MIDLAND PROJECT
DOCKET NOS 50-329, 50-330
RESOLUTION OF NRC CONCERNS RELATED TO
THE STAFFS SAFETY EVALUATION REVIEW
OF THE MIDLAND FIRE PROTECTION PROGRAM
FILE B9.5.1, 0485.11 SERIAL 16795

RESOLUTION OF NRC STAFF CONCERNS
OF THE MIDLAND FIRE PROTECTION PROGRAM

MIDLAND UNITS 1 AND 2
DOCKET NO 50-329 AND 50-330
CONSUMERS POWER COMPANY

FIGURE 14

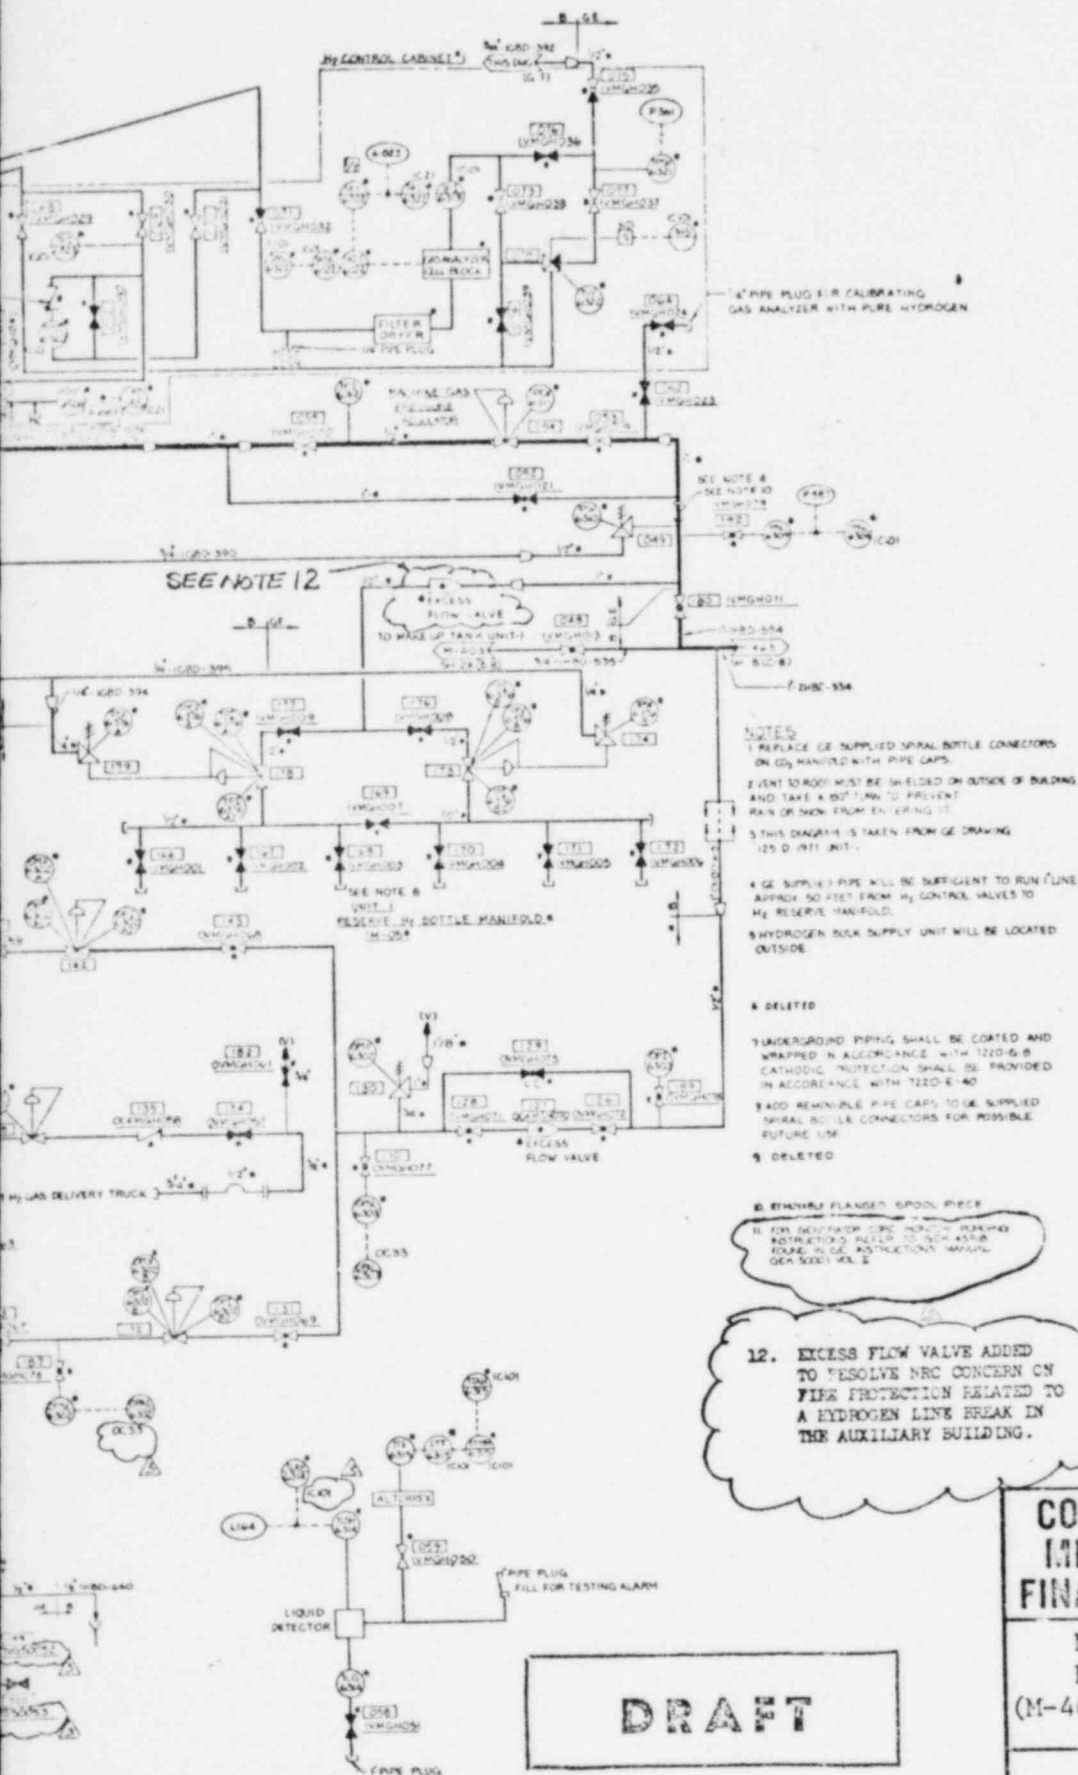
The applicant has not provided adequate information for the Staff to review the hazards posed by the routing of hydrogen piping through safety-related areas. To meet the guidelines of Sections D.2.b of Appendix A to BTP ASB 9.5-1, the staff will require hydrogen piping to be sleeved or to restrict hydrogen flow in case of a line break.

The existing hydrogen system has an excess flow valve located in the main header supply line which is designed to shutdown the flow in the case where flow exceeds 25 SCFM. This excess flow valve is identified as valve QCKMGH 070 on the attached Figure 14, which is the draft FSAR Figure 9.3-41, Sheet 1, and the P&ID for the hydrogen supply system. Calculations show that in the case of a circumferential line break, the hydrogen flow would be about 730 SCFM. In addition a second excess flow valve, such as that indicated on Figure 14, or equivalent protection will be installed to shutdown the flow from the reserve bottled hydrogen source. Normal operating pressure of this system is 90 psig. A low pressure hydrogen alarm located downstream of the excess flow valve will notify the operators. Based on installation of the two excess flow valves indicated on Figure 14, the flow of hydrogen from either the main or reserve source will be cut off in the event of a line break in the auxiliary building.
